MLAIC
Small Arms Committee Report

Name	Gerhard Lang
Date	2017.05.23
Email	gerhard.lang.sila@t-online.de
Discipline	Lamarmora, Minié
Rep. No.	5/2018

Can Pedersoli move the rear sight on the reproduction of the 1857 Württembergischen rifle closer to the muzzle, further from the aiming eye of the shooter?

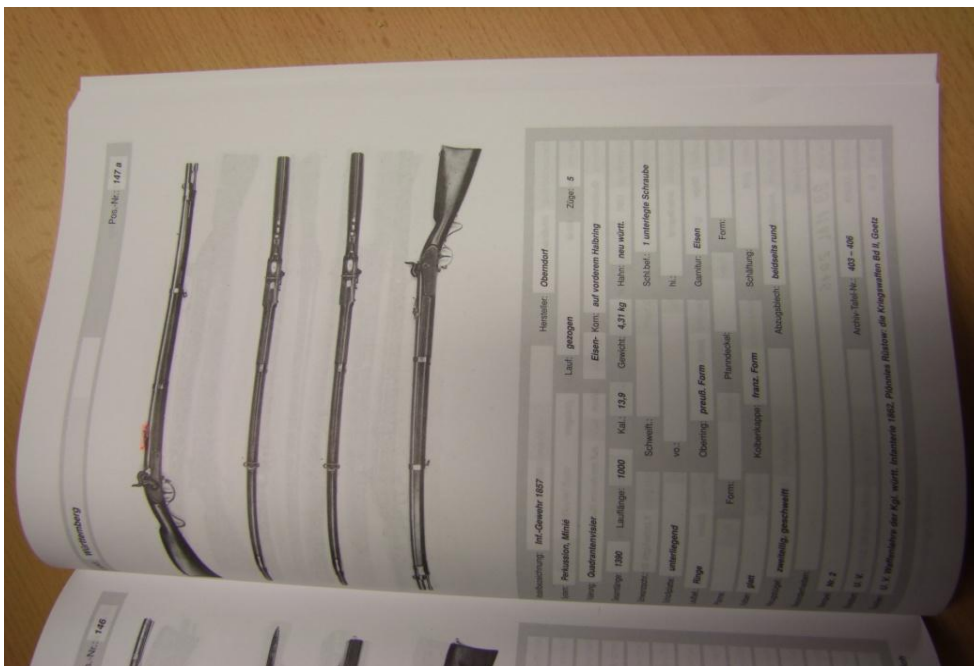
Sometime in the years of production Pedersoli moved the rear sight on the 1857 Württembergischen rifles further towards the muzzle to ease aiming. This modification is not acceptable. The sight must be placed to the original position on these reproduction rifles.
